Comments on AS
1428.4 Tactile ...

Comments on AS 1428.4 Tactile Indicators

FIGURE C1(A) DESIGN CRITERIA FOR KERB RAMPS

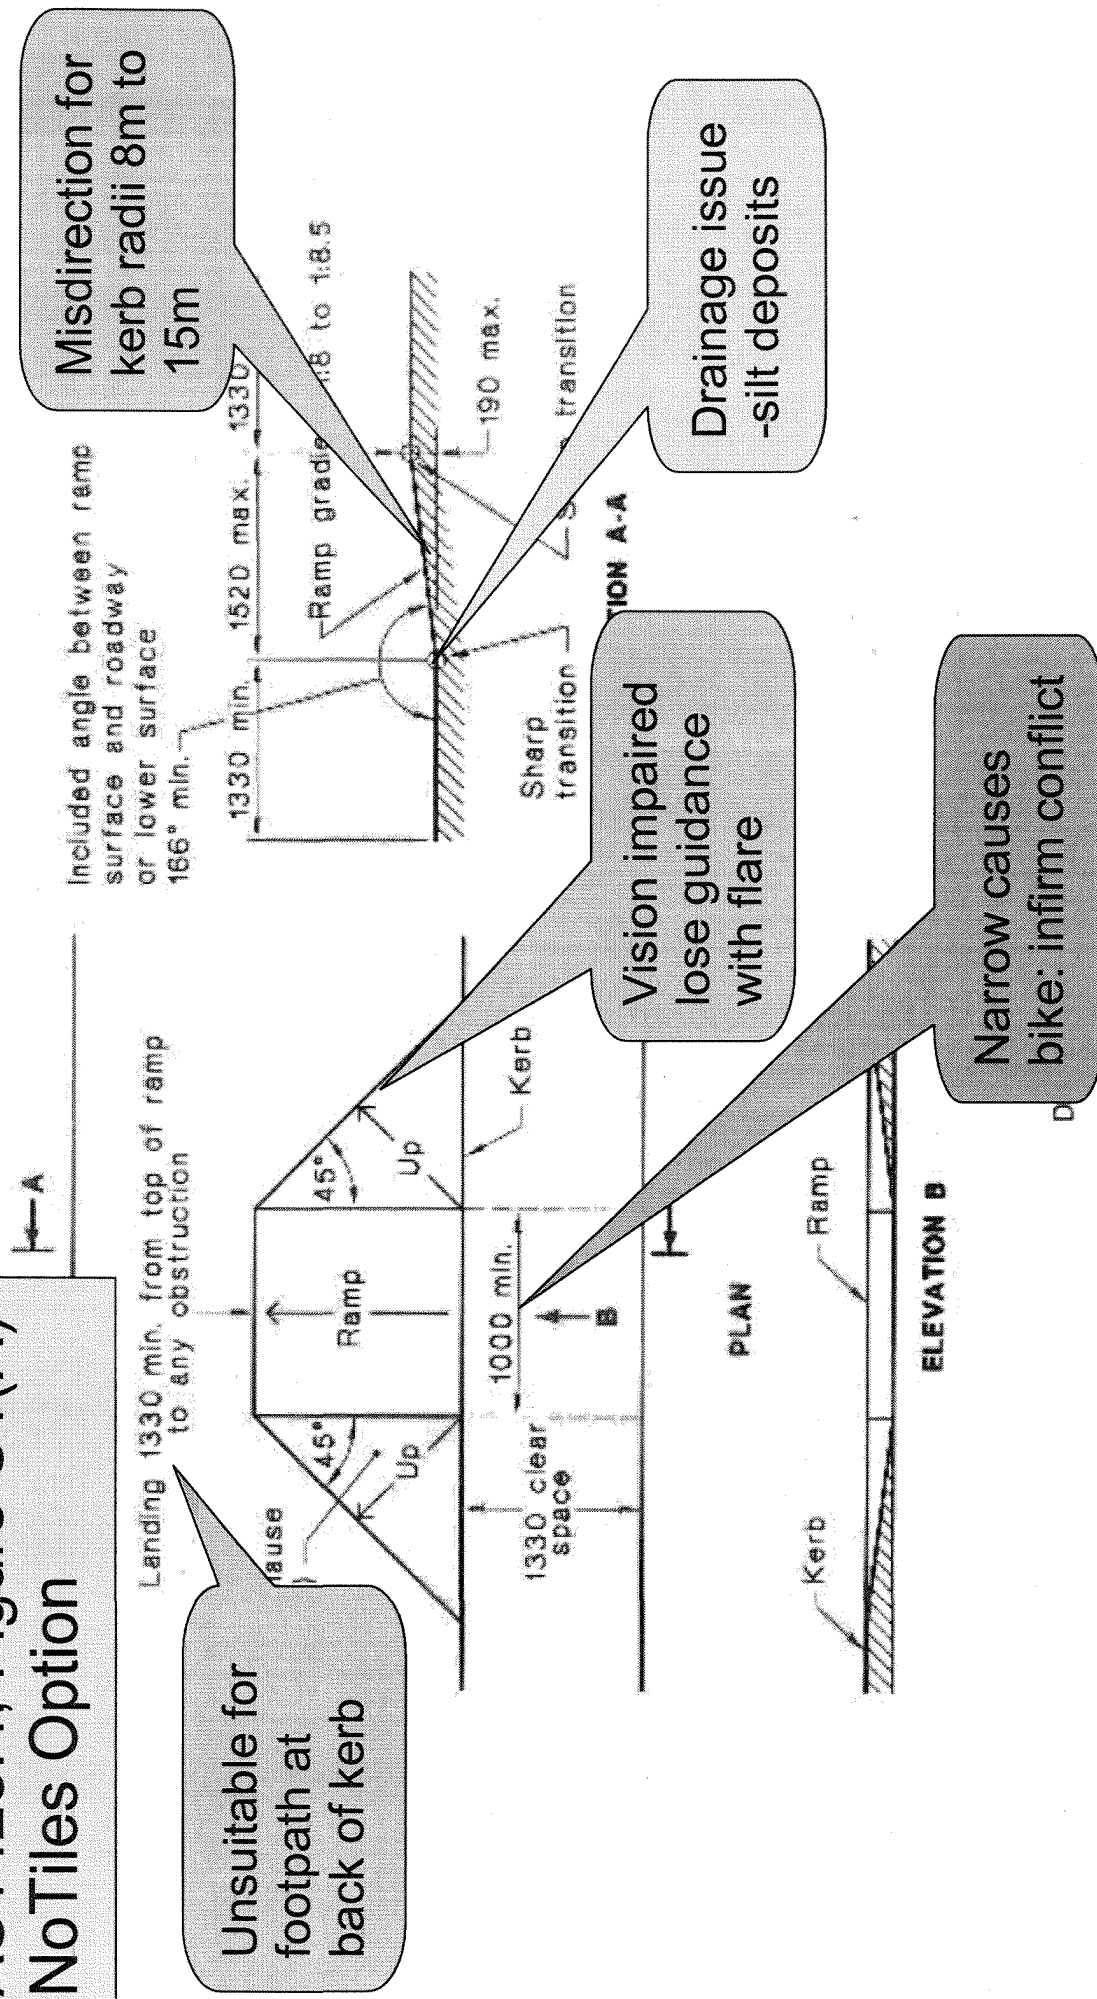
Appendix C3 advises: Where a kerb ramp is 1 in 8 & within 3m, TGSI's are not required. A detailed design should be provided to illustrate this option. (Figure C1(A) does not satisfy drainage requirements, its 166 degree minimum is an error and the 1330 minimum at the base of the ramp is inappropriately provided to allow a wheelchair to turn on the crosswalk.)

Figure C1A: General, 1 in 8 ramp, Single Creates congestion, drainage unspecified

AS1428.4, Figure C2(B)
3m verge, no tiles

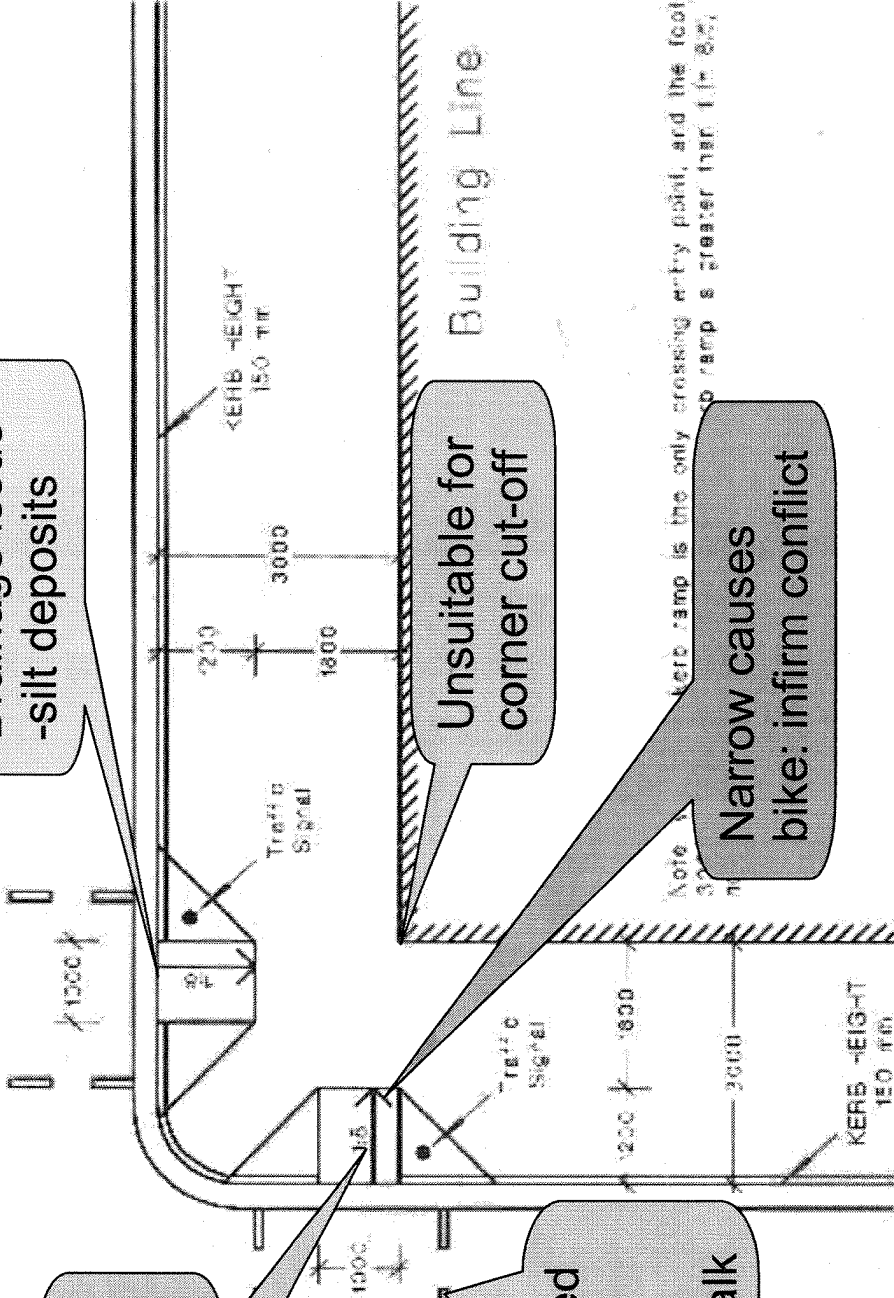
Misdirection
for kerb radii
8m to 15m

Drainage issue
-silt deposits

AS1428.4, Figure C2(C)

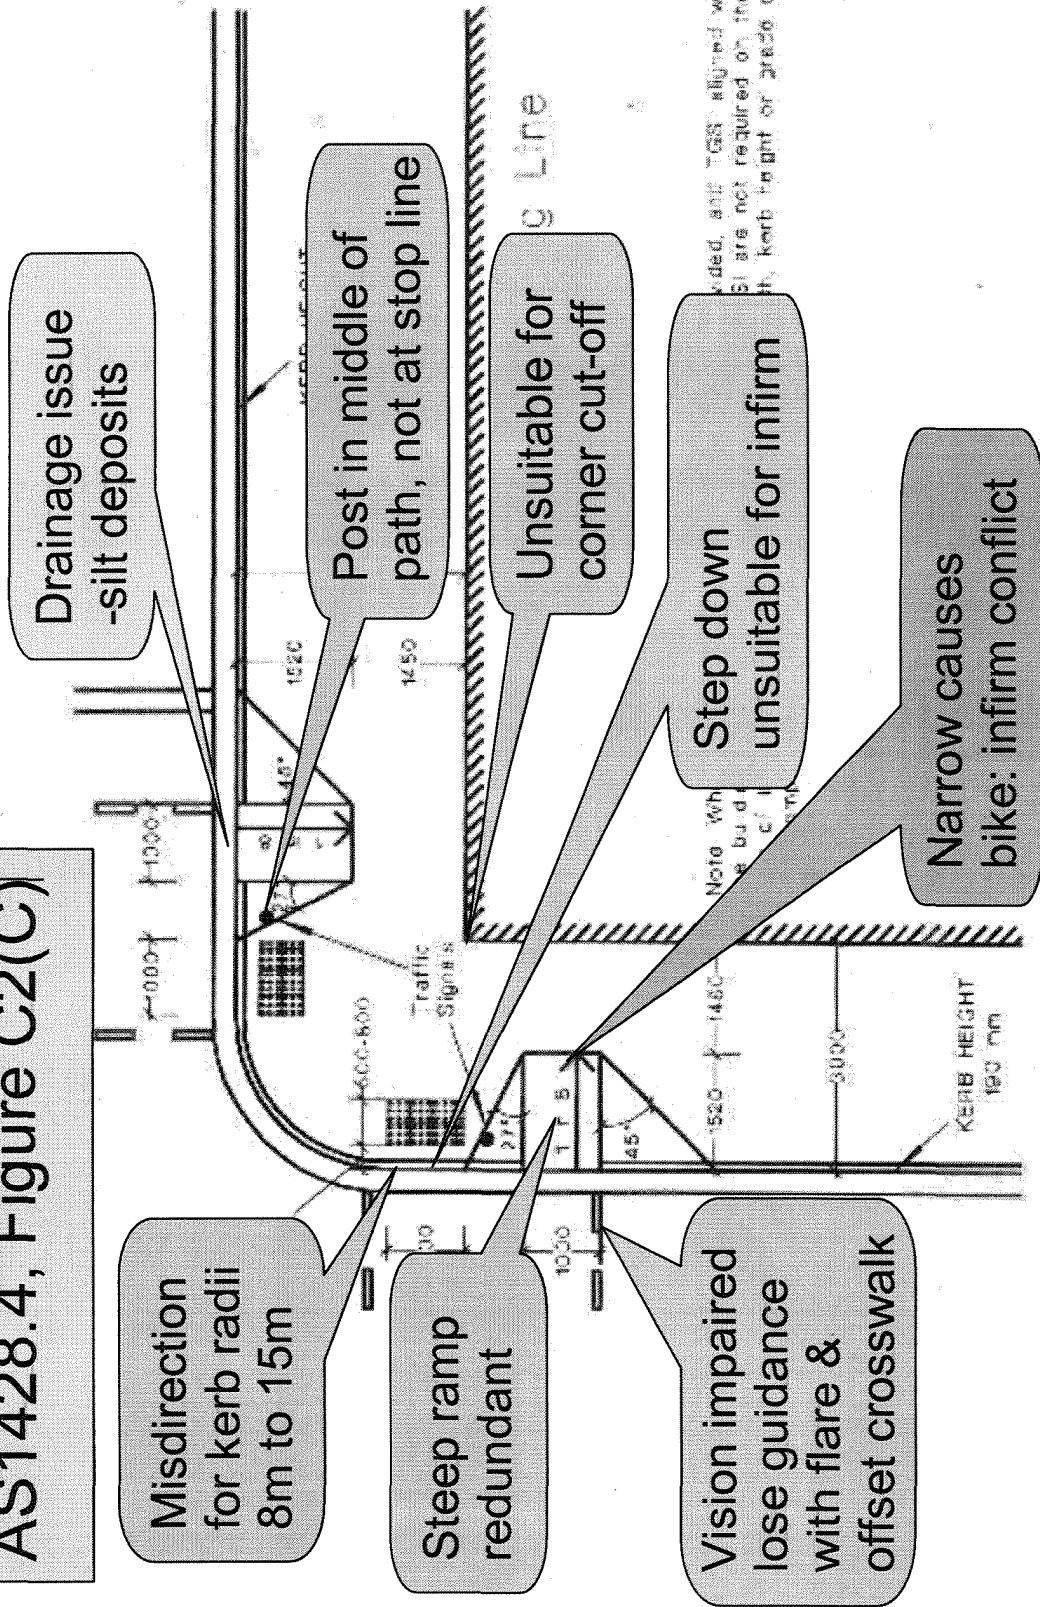
Figure C1C: R2, F3m, 150K, Single Creates congestion, does not guide visually impaired

AS1428.4, Figure C2(D)
offset crosswalk

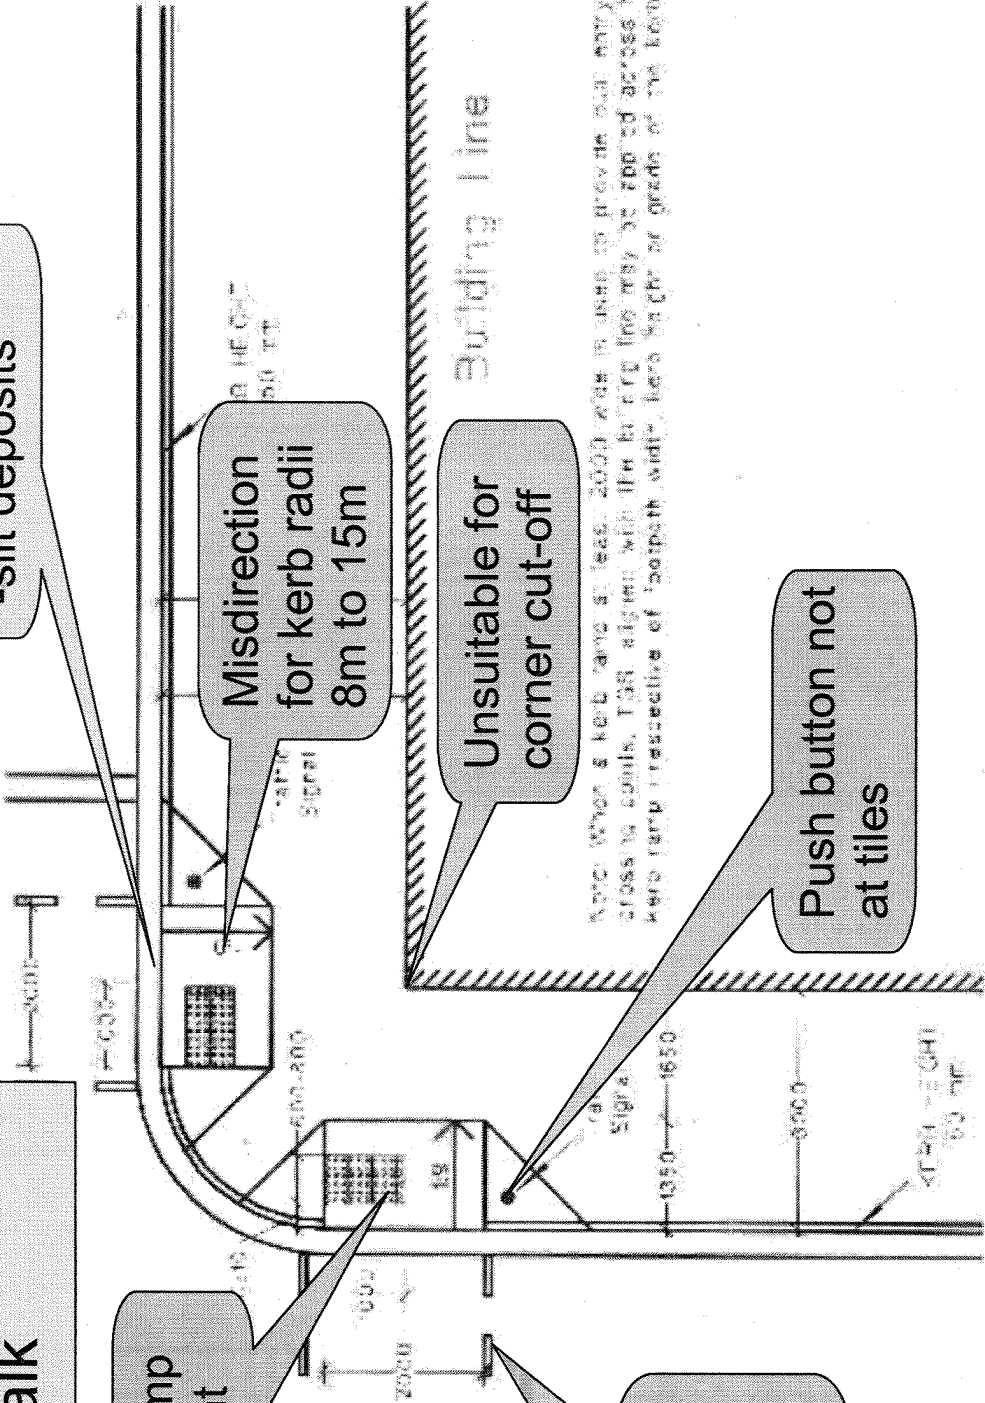
Drainage issue
-silt deposits

Steep ramp
redundant

Misdirection
for kerb radii
8m to 15m

Unsuitable for
corner cut-off

Vision impaired
lose guidance
with flare &
offset crosswalk

Push button not
at tiles

AS1428.4, Figure C2(E)
narrow ramp

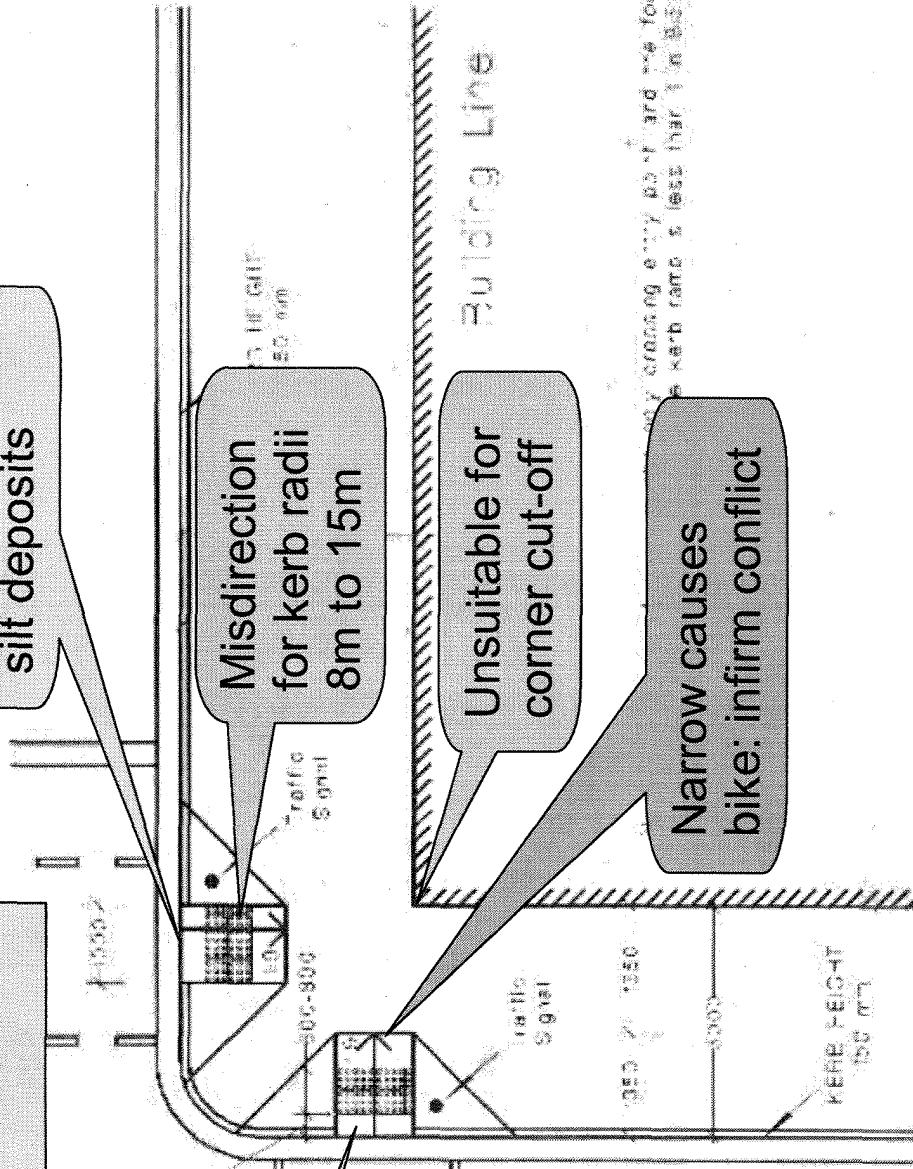
Drainage issue -
silt deposits

Steep ramp
redundant

Misdirection
for kerb radii
8m to 15m

Unsuitable for
corner cut-off

Narrow causes
bike: infirm conflict

Vision impaired
lose guidance
with flare &
offset crosswalk

AS1428.4, Figure C6
wide verge

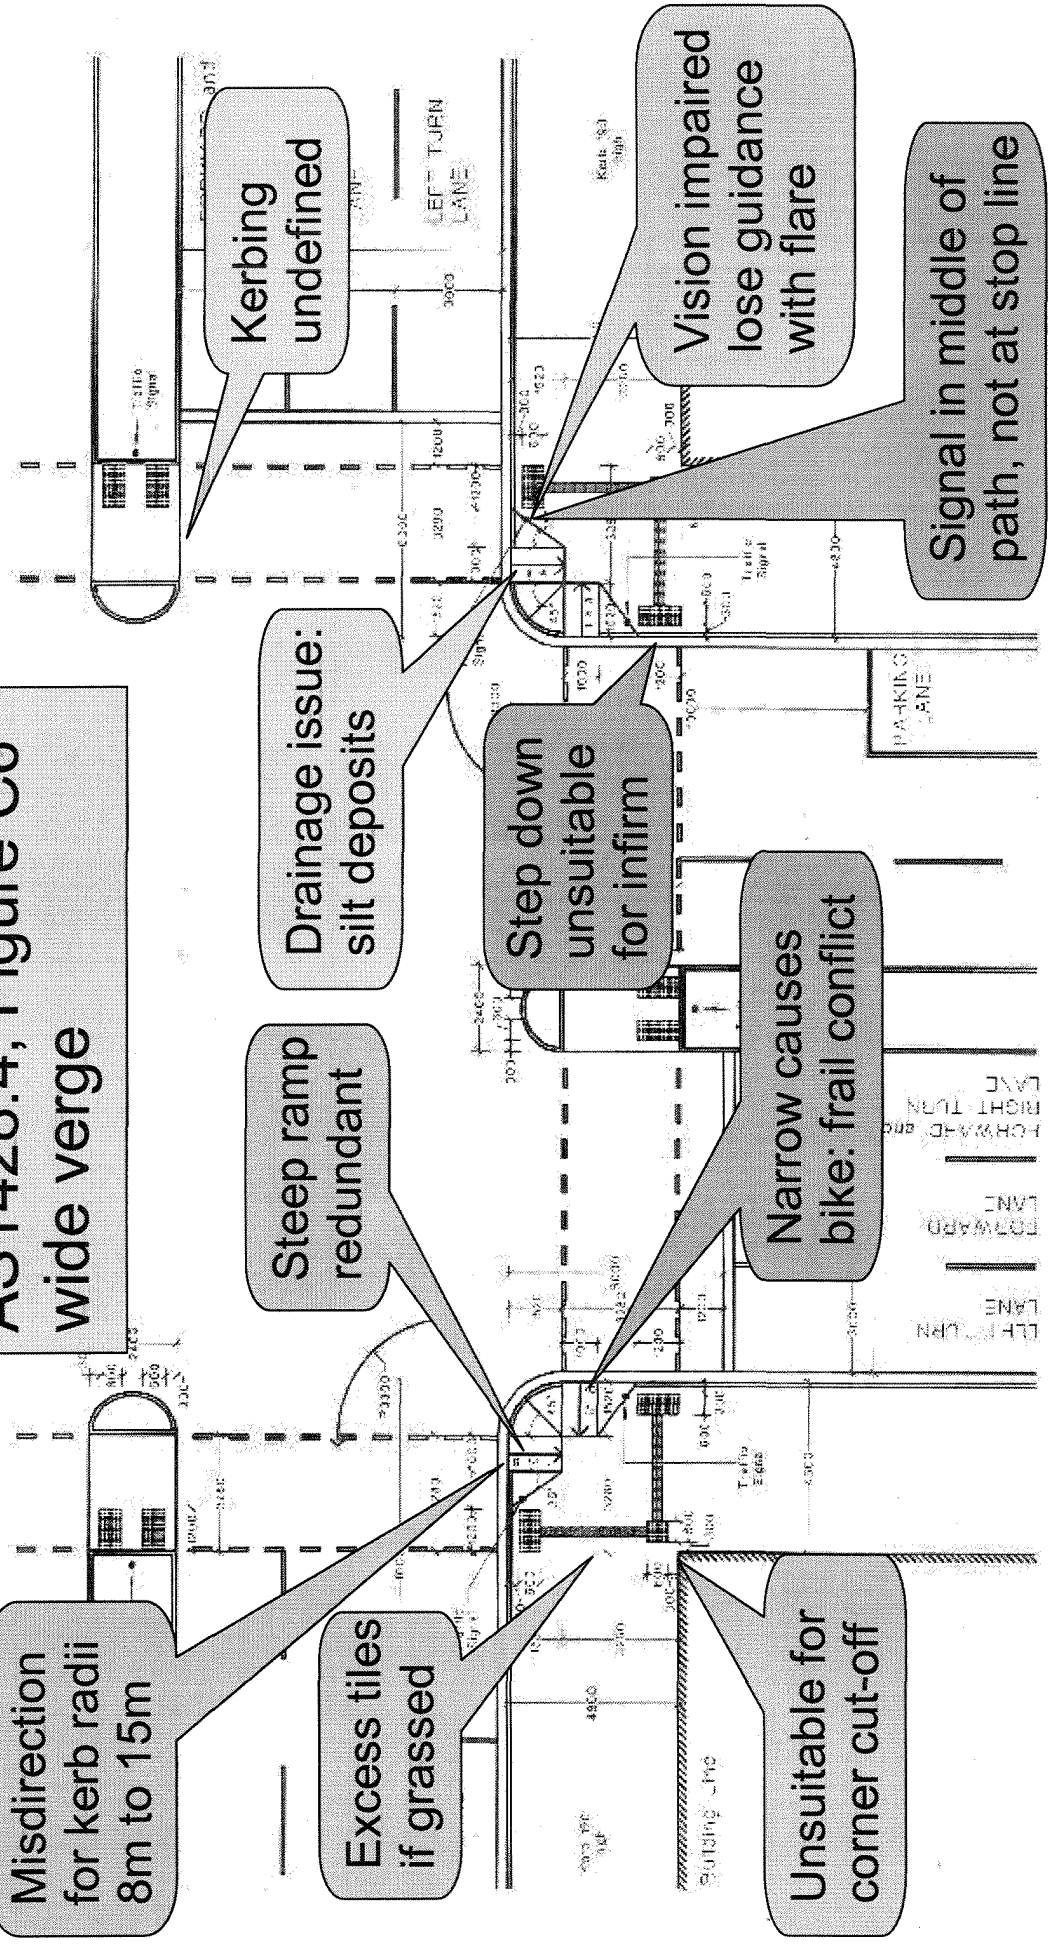
Misdirection
for kerb radii
8m to 15m

Excess tiles
if grassed

Steep ramp
redundant

Drainage issue:
silt deposits

Step down
unsuitable
for infirm

Narrow causes
bike: frail conflict

Unsuitable for
corner cut-off

Kerbing
undefined

Vision impaired
lose guidance
with flare

Signal in middle of
path, not at stop line

AS1428.4, Figure C10(c)
 median, step down

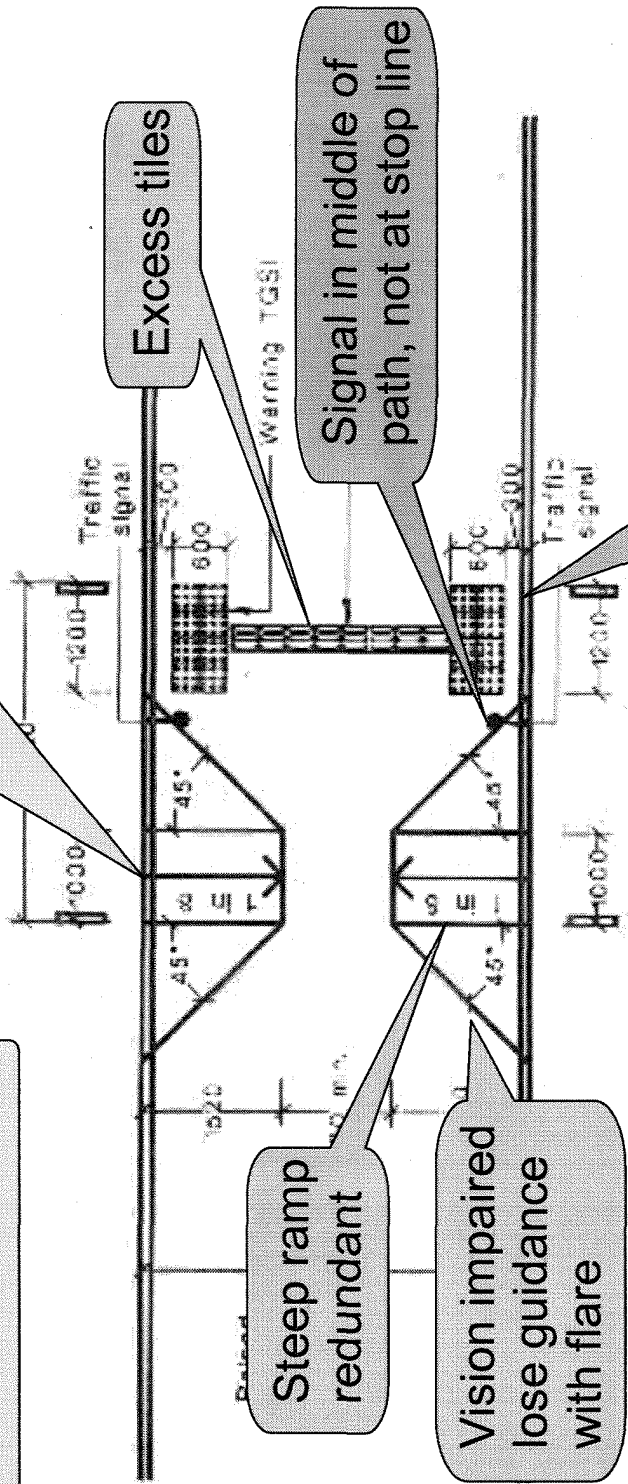
Narrow causes
 bike: infirm conflict
